ROLLING ACRES ESTATES

ENVIRONMENTAL REVIEW TEAM REPORT
ON
ROLLING ACRES ESTATES
SALEM, CONNECTICUT
SEPTEMBER, 1976

ENVIRONMENTAL REVIEW TEAM REPORT
ON
ROLLING ACRES ESTATES
SALEM, CONNECTICUT

TOPOGRAPHY

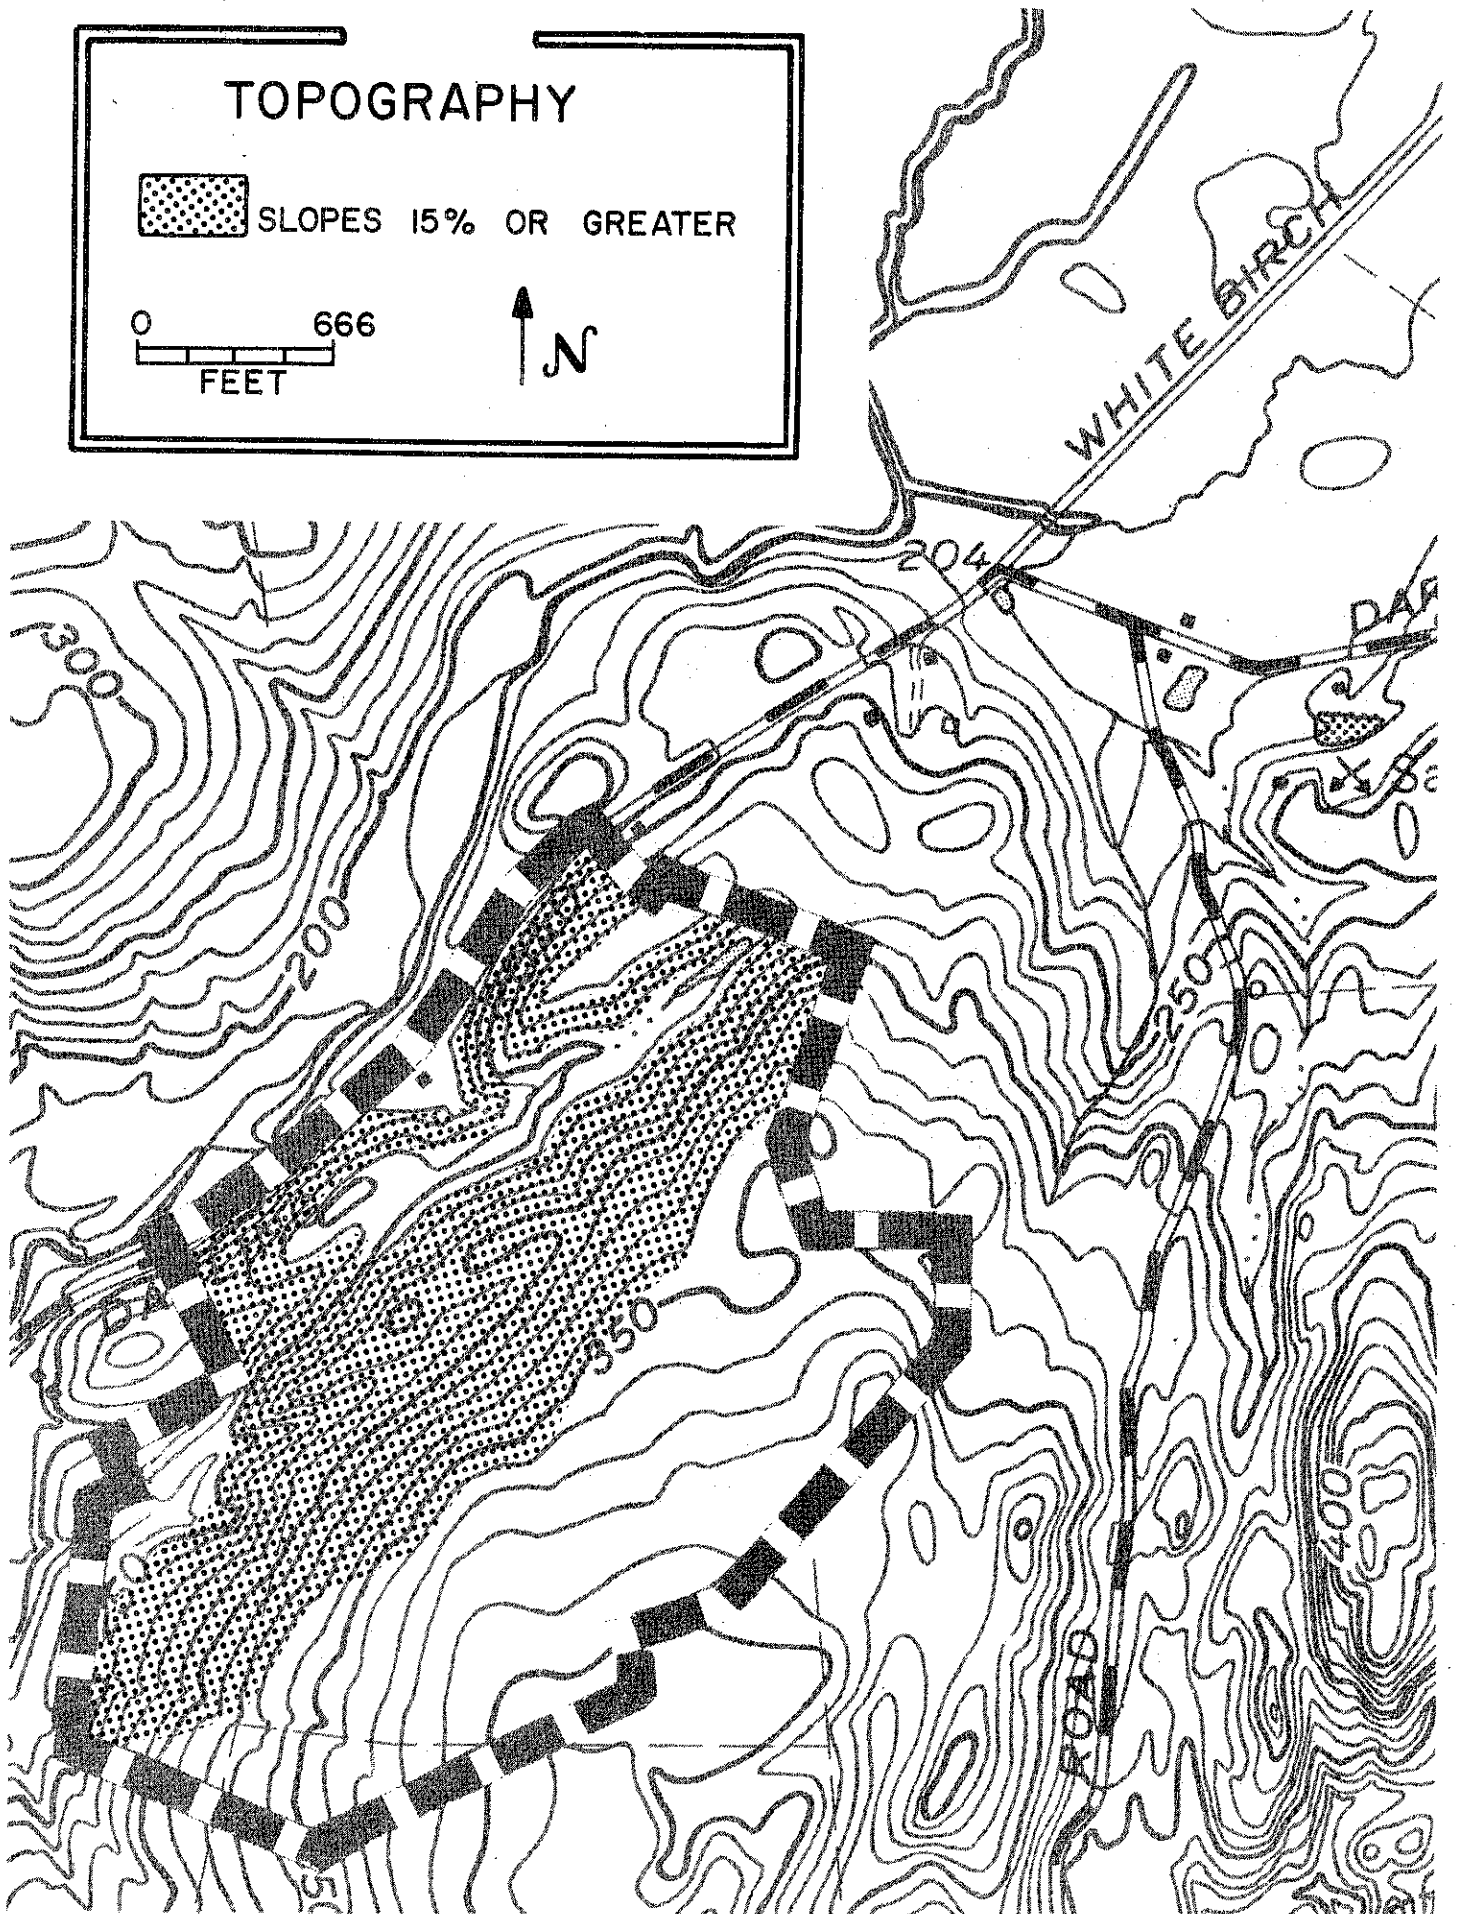
The site under review in Salem is located in the southwest corner of the Town. As illustrated on the TOPOGRAPHY MAP on the following page, approximately one-half of the site is characterized by a rugged terrain with slopes exceeding 15%. The broad hilltop exhibits much less variation in topography. Much of the hilltop area is seasonally wet as a high water table appears to be supported in the thicker low permeability tills.

Both the gneiss and the quartzite are sturdy rocks and present no difficulty in terms of foundation support. The only problem area with such rocks is where the slope of the land is parallel with the dip, or plunge, of the rock as is the case with some areas upslope from Darling Road. Where bedrock is exposed in this area, none, however, was observed. There is potential for rockslides to occur as a natural peeling off. If rock in this area is uncovered and left exposed, there is a possibility for frost action combined with natural ground water movements down slope to create a situation conducive to rocksliding.

SOIL MAP
ROLLING HILLS ESTATES
SALEM, CONNECTICUT

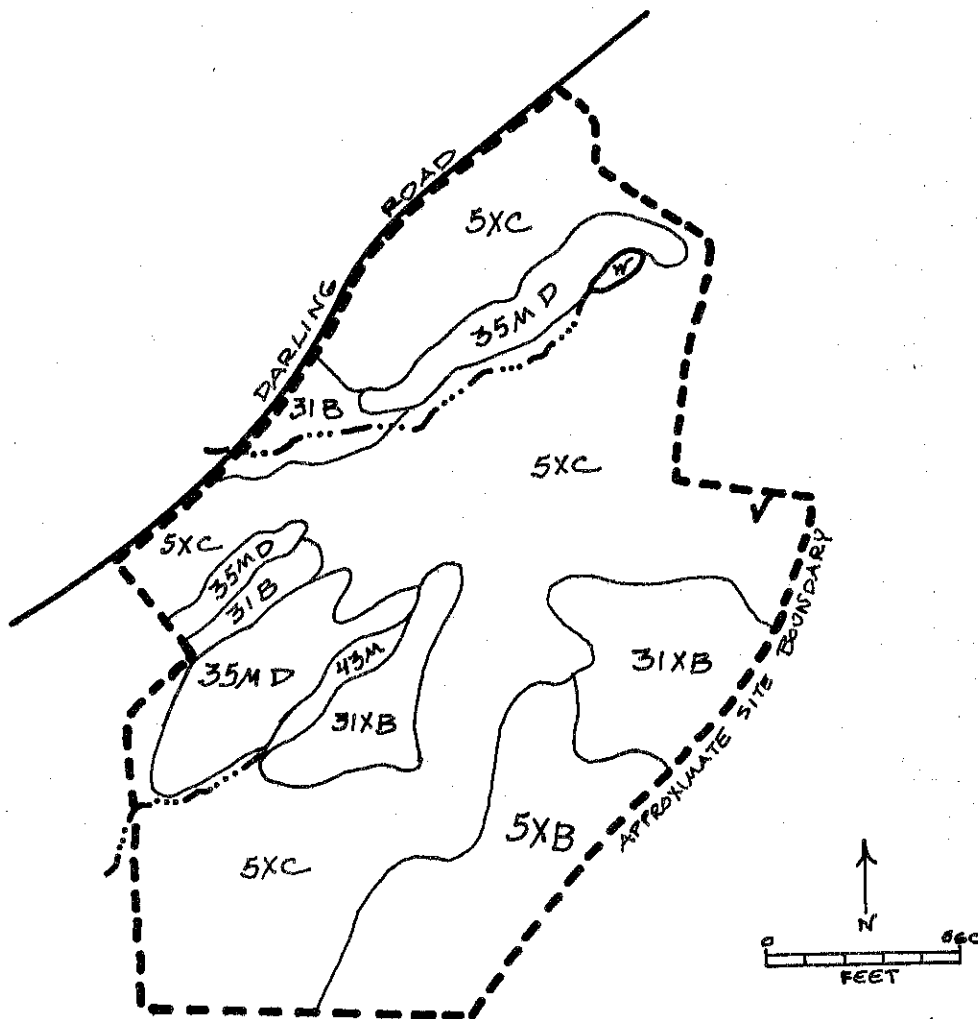
A detailed soils map of the properties is given in the Appendix to this report. As the map is an enlargement from the original 1320'/inch scale to 660'/inch, the soil boundary lines shown should not be viewed as absolute boundaries, but rather as guidelines to the distribution of soil types on the property. The soils map, along with the Special Soils Report, Southeastern Connecticut Region (USDA, SCS, 1969), can serve as an educational tool regarding the identification and interpretation of soils. The natural soil group is also given for each soil. The Natural Soil Group Report published by SCS and the New London County Cooperative Extension Service provides a clear explanation of the natural soil groups.

The most imposing site limitations are the steep slopes and the hardpan soils. Homes can be designed for slopes, and they can also be located on less steep portions of the property. Steep slope areas should be avoided if possible when locating on-site septic systems. The Water Compliance Unit of DEP should be contacted where septic systems will be constructed on slopes of fifteen percent or greater. Steep slopes combined with the fragipan both along Darling Road and elsewhere on the site may suggest that homes be protected with curtain drains or similar devices, especially where homes are placed in a deep cut. The hardpan will cause the water table to rise during times of heavy rainfall and this is one reason for the moderate to severe ratings for on-site sewage and basements. Sub-surface sewage disposal systems can be designed to function satisfactorily in hardpan soils. Engineering provisions must be made to compensate for the soil limitations.
